RE: Data Response, Set 2C  
Ivanpah Solar Electric Generating System (07-AFC-5)

# Ivanpah Solar Electric Generating System (ISEGS) (07-AFC-5)

## Data Response, Set 2C (Responses to Data Requests: Closure & Restoration, Soil & Water, and Visual Resources)

**FIGURE DR147-1**  
**KOP LOCATIONS**  
IVANPAH SOLAR ELECTRIC GENERATING SYSTEM

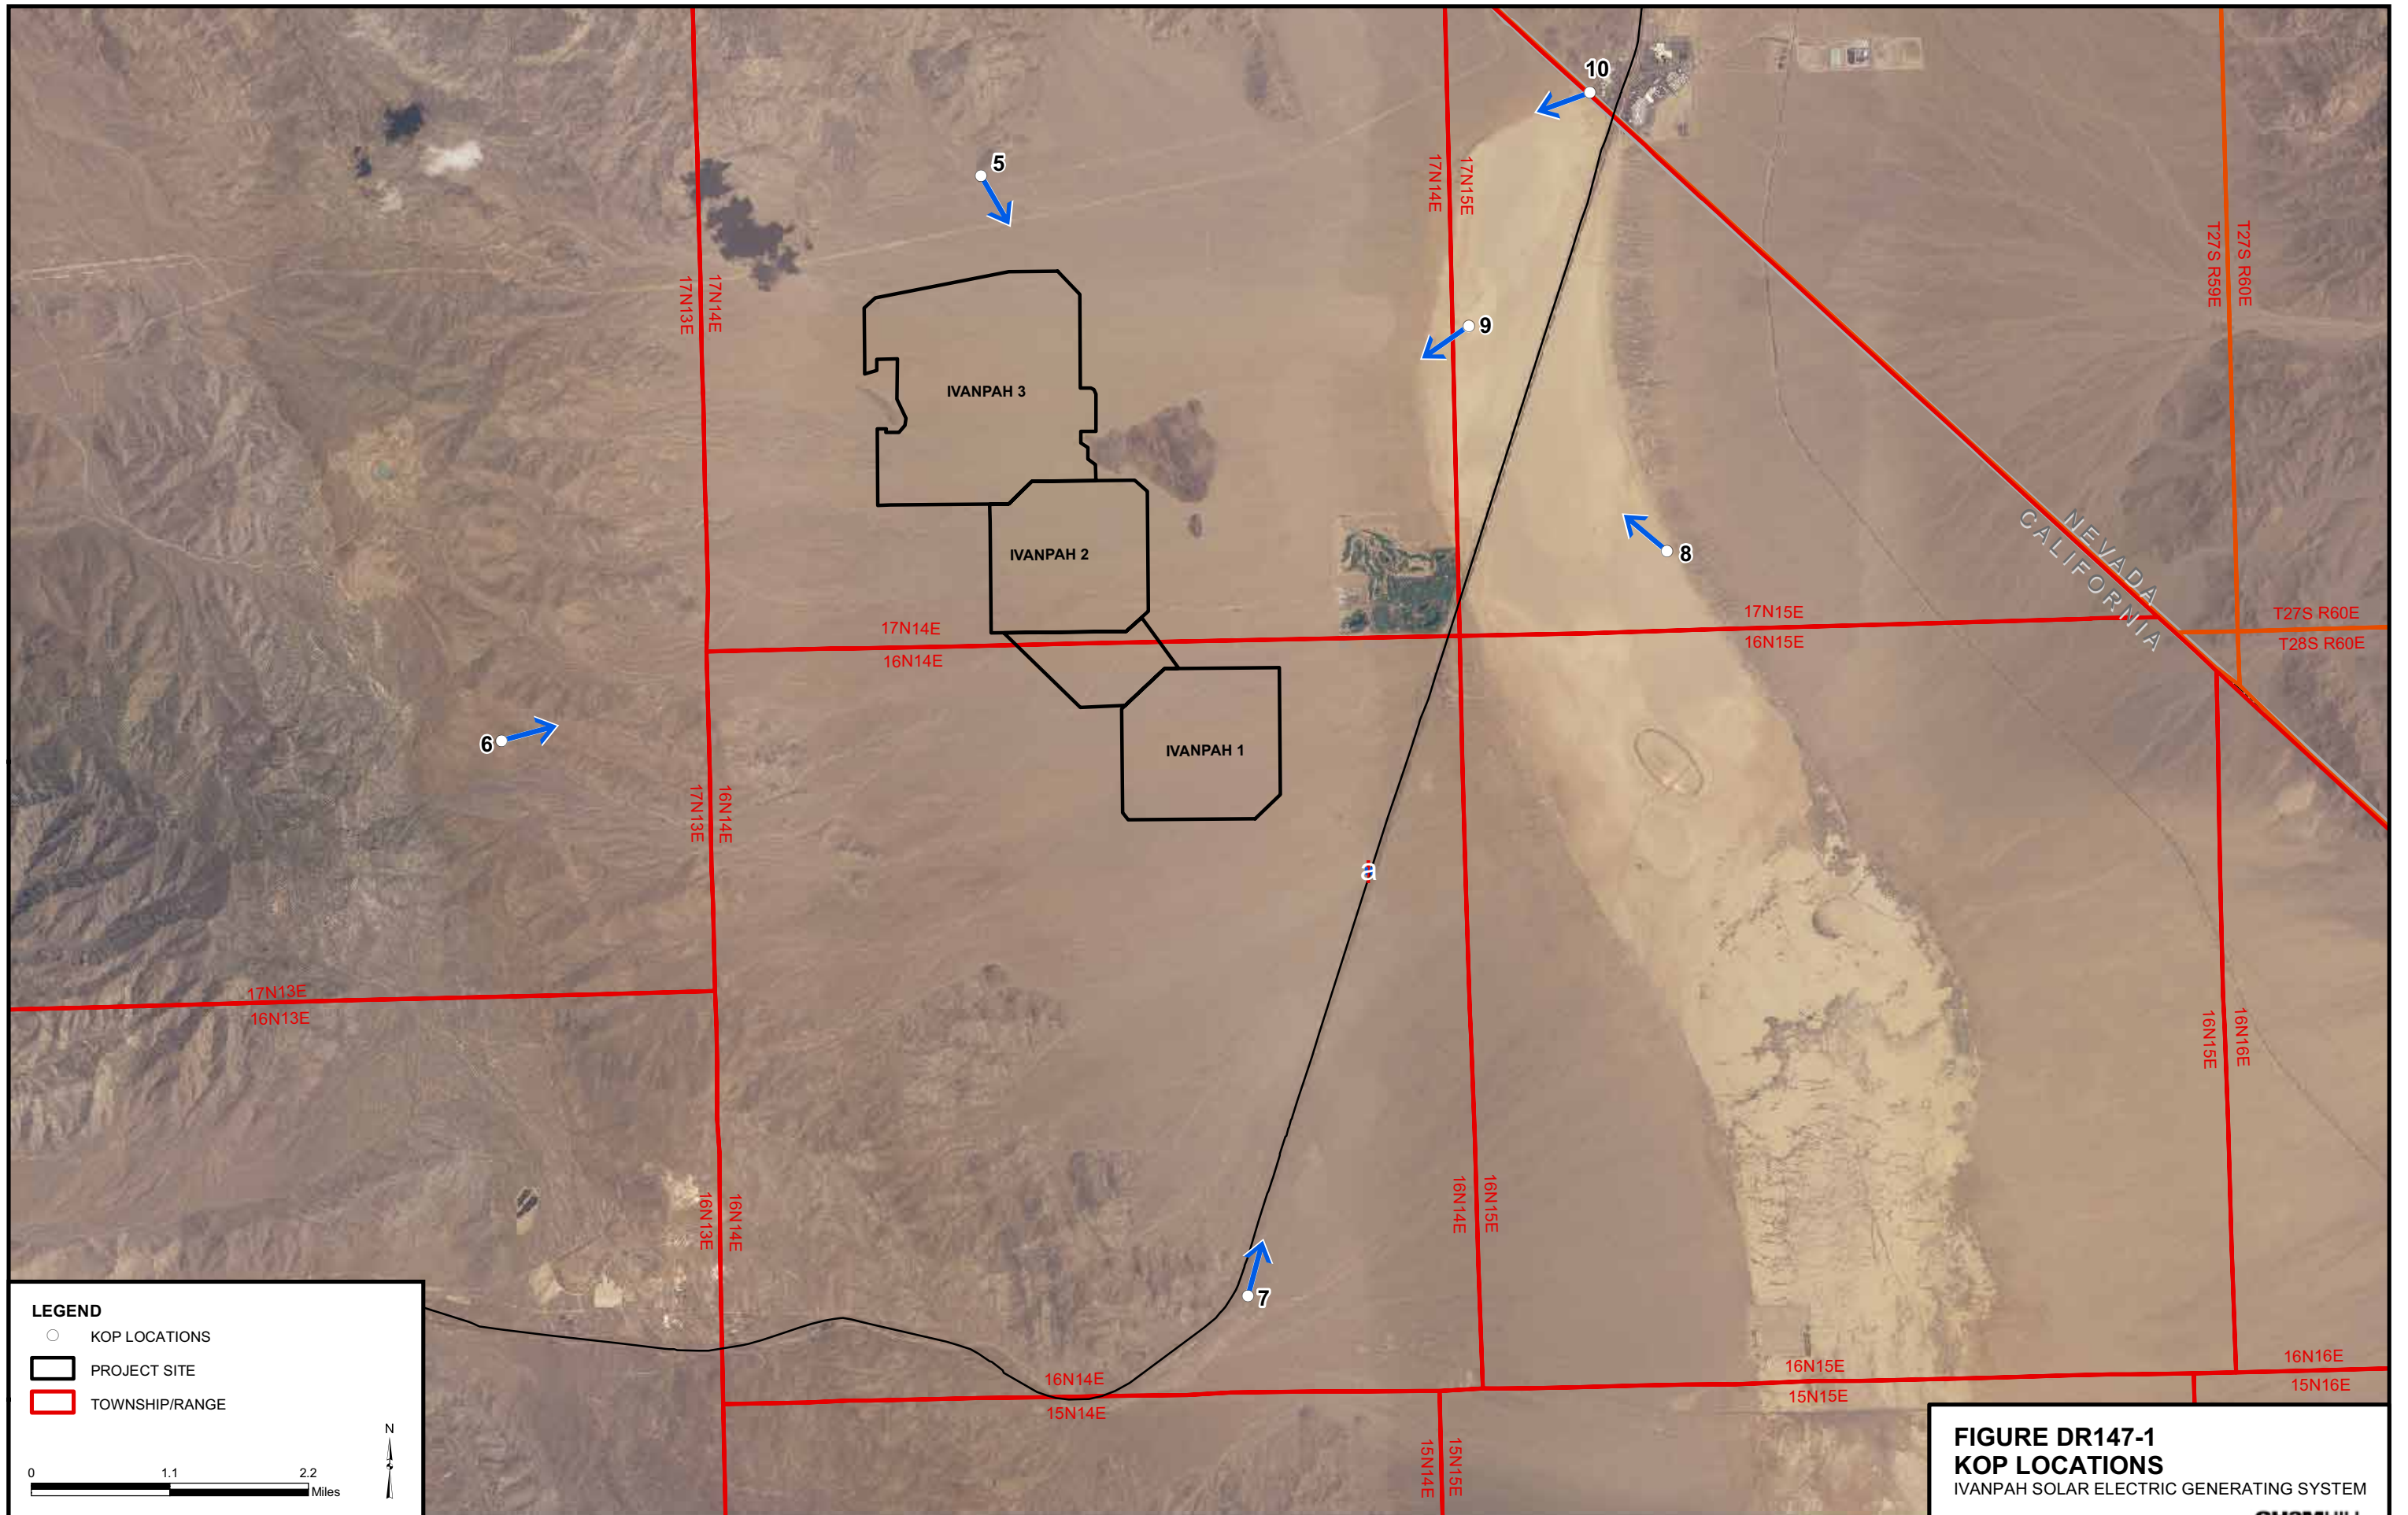
147. Please provide visual simulations, utilizing 'normal' (50 mm equivalent or approximately 40-degree angle of view), of the following new recreational KOPs:

Figure DR147-1 shows the locations of all six KOP existing condition photographs (Figures DR148-1 through DR148-6) and the visual simulations (Figures DR147-2 through DR147-7), as well as the direction that the camera was pointed when the photo was taken. The KOPs are as follows:
